Sub.:- Modification in Vigilance Control Device in Tap changer Electric locomotives.

Modification Sheet No. RDSO/2015/EL/MS/0444 (Rev. '0')

Modification in Vigilance Control Device in tap changer electric locomotives for:

3.0 Existing Arrangement with cross-references of respective design document:

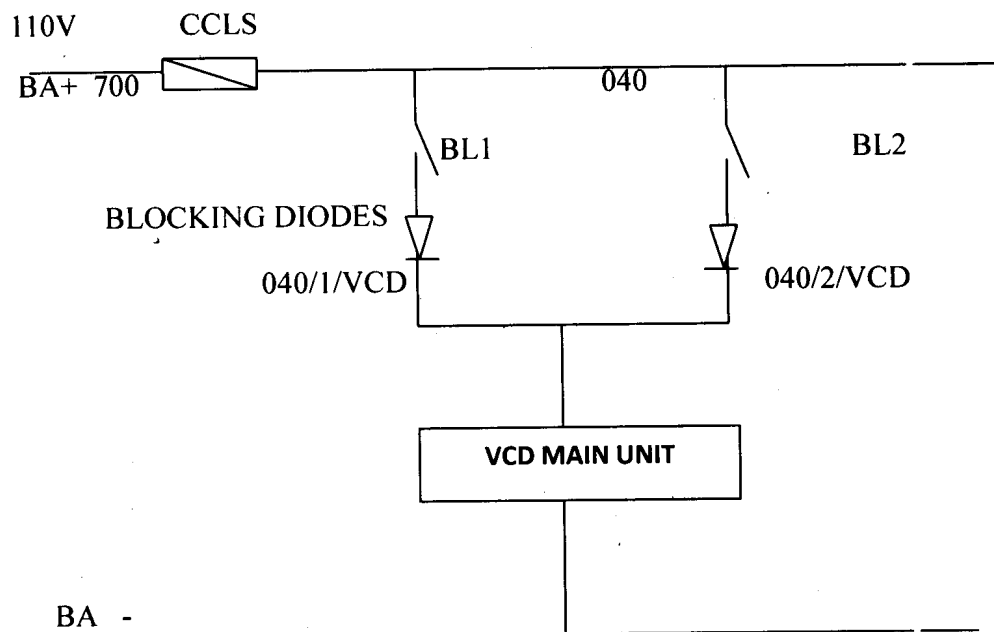
- 3.1 Presently 110 Volt DC power supply to VCD main unit is provided direct from battery as per VCD specification no. RDSO/2008/EI/SPEC/0025, Rev-5.

- 3.2 At present vigilance cycle gets reset by pressing horn as well.

To activate VCD main unit, supply will be fed through BL key in Vigilance Control Device as shown below. This modification will prevent energizing of VCD of rear loco.

Note: Cable no 003 to be removed from terminal no. L of VCD TB

Remove the cable no. 22J and 22K for deactivation of horn pressure switch from VCD 40 pin terminal board.
